Access Compliance Report

Public Rights-of-Way

(Curb Ramps)

Intersection ID: N/A	Main Street: REA_RD	Cross Street: N/A	Location: NW
ADA ID: B9C0979C0A7D	Ramp Type: PerpDiag	Initial Pass/Fail: Fail	Overall Compliance: No
		Severity Score: 30

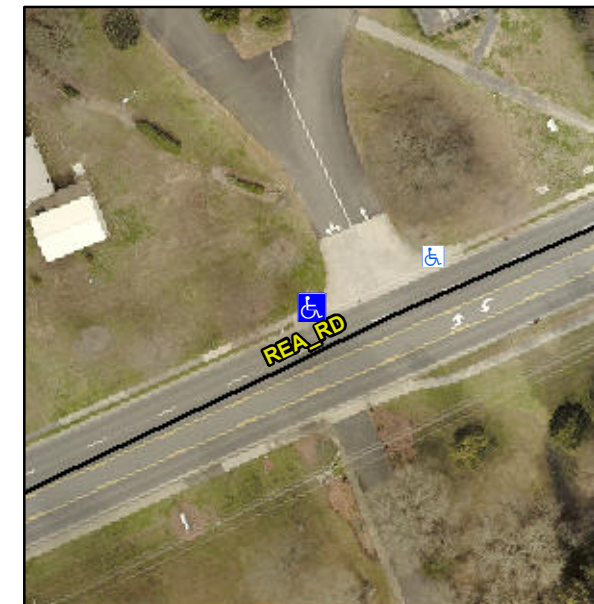
Not Found, R304.5.1, R304.2.2

Compliance	Description	Data	Compliance	Description	Data
N/A	Ramp Length (in)	71.0	No	Ramp Slope (%)	11.5
No	Ramp Width (in)	35.0	Yes	Ramp XSlope (%)	1.0
N/A	Flare Type LT	N/A	N/A	Flare Type RT	N/A
N/A	Flare Slope LT (%)	N/A	N/A	Flare Slope RT (%)	N/A
N/A	Flare Traversable LT?	N/A	N/A	Flare Traversable RT?	N/A
N/A	Landing Length (in)	N/A	N/A	DWS Provided?	N/A
N/A	Landing Width (in)	N/A	N/A	DWS Contrast?	N/A
N/A	Landing Slope (%)	N/A	N/A	DWS Length (in)	N/A
N/A	Landing X Slope (%)	N/A	N/A	DWS Full Width?	N/A
N/A	Landing Curb? (Y/N)	N/A	N/A	DWS Offset (in)	N/A
N/A	Shared Landing?	N/A			
N/A	Gutter Ponding?	N/A	N/A	Gutter Slope (%)	N/A
N/A	Gutter Lip Ht (in)	N/A	N/A	Gutter X Slope (%)	N/A
N/A	Painted X Walk1?	No	N/A	Painted X Walk2?	No
	X Walk 1 Direction	To S		X Walk 2 Direction	To E
N/A	X Walk 1 Width (in)	N/A	N/A	X Walk 2 Width (in)	N/A
	X Walk 1 Slope (%)	5.8		X Walk 2 Slope (%)	2.2
	X Walk 1 X Slope (%)	0.9		X Walk 2 X Slope (%)	3.6

Remove & Replace Curb Ramp With Two New Directional Ramps or Equivalent.
